ST-HL-AE-1339

South Texas Project
Units 1 and 2
Docket Nos. STN 50-498, STN 50-499
Response to Request for Additional Information
Regarding Paluel Vibration Problem
FSAR Question No. 492.6N, 492.7N and 492.8N

South Texas Project
Units 1 and 2
Docket Nos. STN 50-498, STN 50-499
Response to Request for Additional Information
Regarding Paluel Vibration Problem
FSAR Question No. 492.6N, 492.7N and 492.8N

FIGURE 2

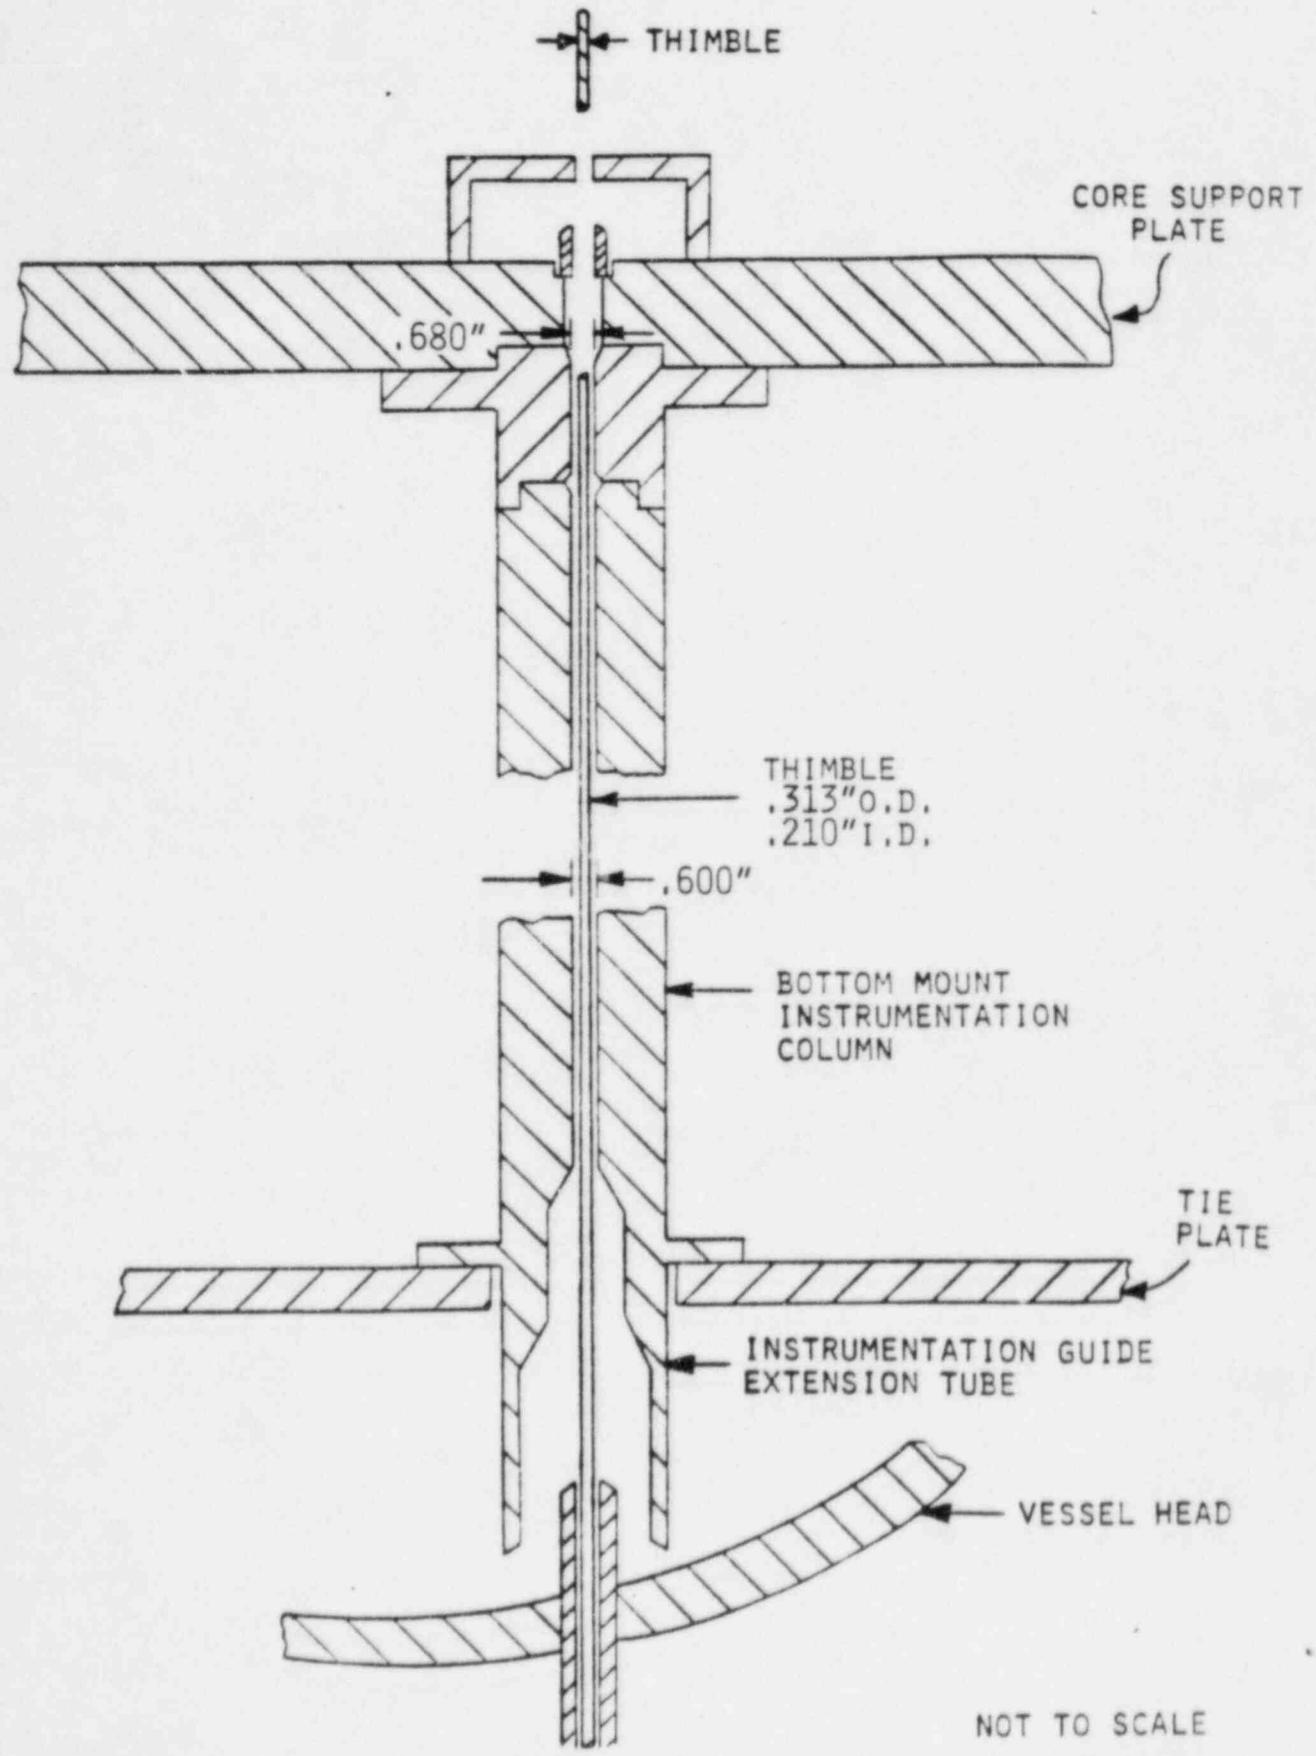
HL&P has investigated the vibration issue and has come to the conclusion that utilizing the heavier walled thimble and reducing the gap around the thimble will result in eliminating excessive thimble vibration. Consequently, HL&P has decided to modify STP Unit 1 such that the BMI column gap size is similar to that of STP Unit 2 (refer to the attached figures in Attachment 2).

As was previously noted, the vibrational problem experienced at Paluel is the vibration of the BMI thimble, not vibration of the reactor vessel lower internals. The South Texas Units 1 & 2 use a flux thimble with a nominal outside diameter of .313". The Paluel units (1, 2, 3, & 4) are using a thimble with an outside diameter of .295". The South Texas thimbles also have a slightly thicker wall than the Paluel thimbles. The larger thimble also results in a smaller annular gap between the flux thimble and the inside of the BMI columns. In conclusion, the stiffer South Texas thimbles, with the smaller gaps, will perform satisfactorily based on the European plant experience to date.
